# Access Compliance Report

## Public Rights-of-Way

### (Curb Ramps)

Intersection ID: 19845	Main Street: CECILIA_LN	Cross Street: KELBURN_LN	Location:	N
ADA ID: 4FC14C3D3C5F	Ramp Type: PerpDiag	Initial Pass/Fail: Fail	Overall Compliance: No	Severity Score: 8.75
Codes/Mitigation Info/Possible Solution		Field Measurements/Component Compliance

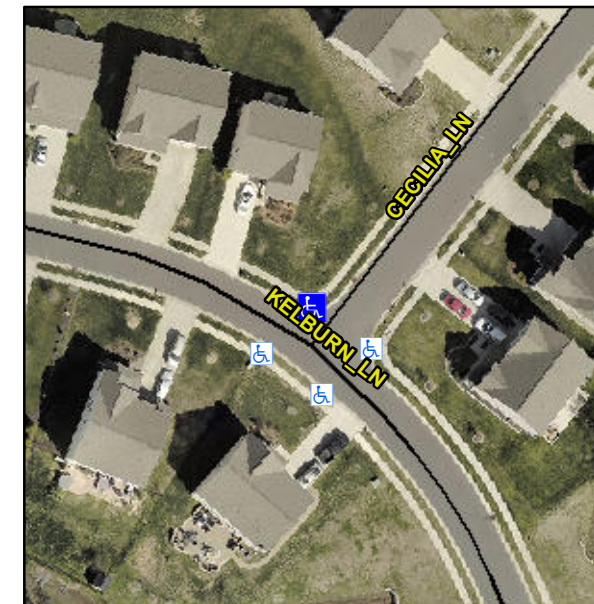
**Not Found, R304.5.1**

Compliance	Description	Data	Compliance	Description	Data
N/A	Ramp Length (in)	52.0	Yes	Ramp Slope (%)	6.1
No	Ramp Width (in)	47.0	Yes	Ramp XSlope (%)	0.3
N/A	Flare Type LT	N/A	N/A	Flare Type RT	N/A
N/A	Flare Slope LT (%)	N/A	N/A	Flare Slope RT (%)	N/A
N/A	Flare Traversable LT?	N/A	N/A	Flare Traversable RT?	N/A
N/A	Landing Length (in)	N/A	N/A	DWS Provided?	N/A
N/A	Landing Width (in)	N/A	N/A	DWS Contrast?	N/A
N/A	Landing Slope (%)	N/A	N/A	DWS Length (in)	N/A
N/A	Landing X Slope (%)	N/A	N/A	DWS Full Width?	N/A
N/A	Landing Curb? (Y/N)	N/A	N/A	DWS Offset (in)	N/A
N/A	Shared Landing?	N/A			
N/A	Gutter Ponding?	N/A	N/A	Gutter Slope (%)	N/A
N/A	Gutter Lip Ht (in)	N/A	N/A	Gutter X Slope (%)	N/A
N/A	Painted X Walk1?	No	N/A	Painted X Walk2?	No
	X Walk 1 Direction	To SW		X Walk 2 Direction	To SE
N/A	X Walk 1 Width (in)	N/A	N/A	X Walk 2 Width (in)	N/A
	X Walk 1 Slope (%)	0.6		X Walk 2 Slope (%)	0.8
	X Walk 1 X Slope (%)	1.8		X Walk 2 X Slope (%)	0.2

N/A	Ramp inside XWalk1?	N/A	N/A	Ramp inside XWalk2?	N/A
	Road Slope (%)	1.7	N/A	Clear Space?	N/A
	Road X Slope (%)	1.5	N/A	Clear Space to XWalk (in)	N/A
N/A	Any Obstructions?	N/A	N/A	Storm Grate/Utility Hazard?	N/A
	Obstruction Type			Storm Grate/Utility Type	
		N/A			N/A
			Yes	Surface Condition? (G/P)	Good

**Remove & Replace Curb Ramp With Two New Directional Ramps or Equivalent.**
